**LEE'S SUMMIT**  
MISSOURI  
Development Services Department

## Development Services Staff Report

<b>File Number</b>	PL2022-192 - REZONING from RP-2 to CBD and PRELIMINARY DEVELOPMENT PLAN - Ellis Glen
<b>Applicant</b>	MKEC Engineering, applicant
<b>Location</b>	102-110 SW Market St.
<b>Planning Commission Date Heard by</b>	August 25, 2022 Planning Commission and City Council
<b>Analyst</b>	C. Shannon McGuire, Planner
<b>Checked By</b>	Hector Soto, Jr., AICP, Senior Planner Kent Monter, PE, Development Engineering Manager

Figure 1

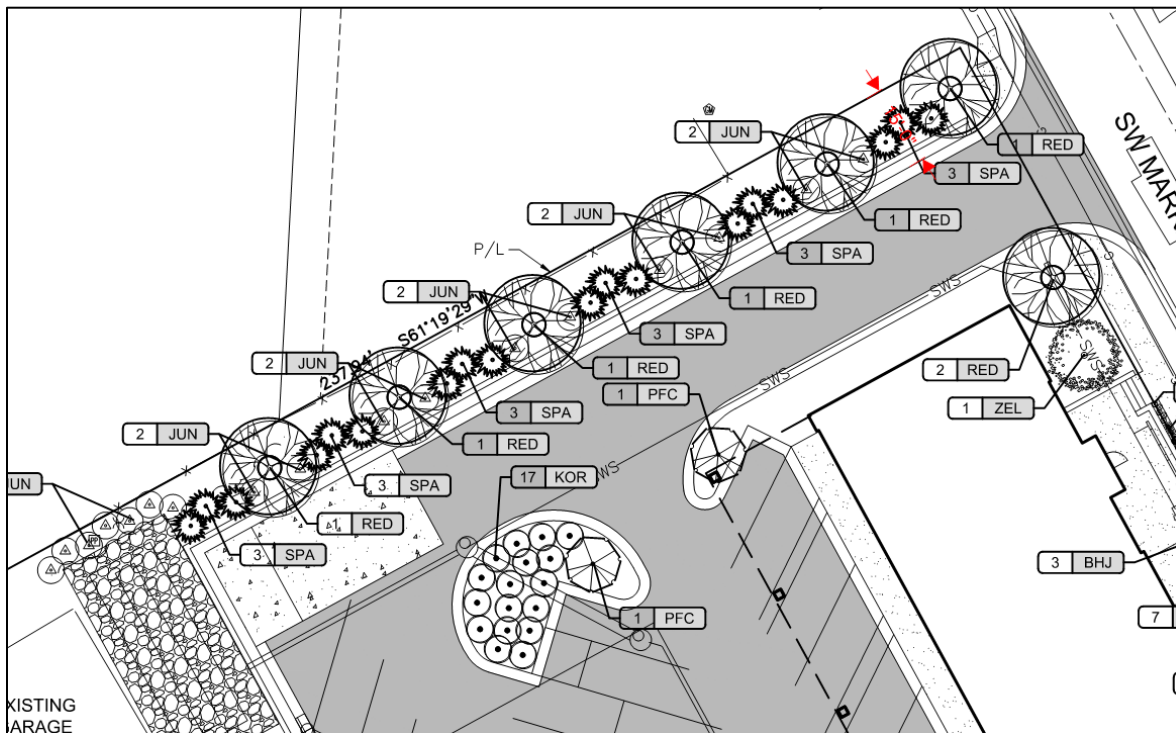
- **Required** - The UDO requires parking lots to be set back a minimum 20' from any residential district or use.
- **Proposed** - The applicant proposes to reduce the required parking lot setback from 20' to 15' along the north property line (Figure 1) and 13' 8" adjacent to the south property line (Figure 2).
- **Recommended** – Staff supports the requested modification. The reduced setback is a result of the applicant's desire to maximize the available parking on the site. The encroachment is limited to drive aisles with all parking stalls meeting the setback requirements. The applicant has proposed to install additional landscaping adjacent to the areas of encroachment. For these reasons staff feels the request is reasonable.

1. A modification shall be granted to reduce the required parking lot setback from 20' to 15' along the north property line and 13' 8" along the south property line.
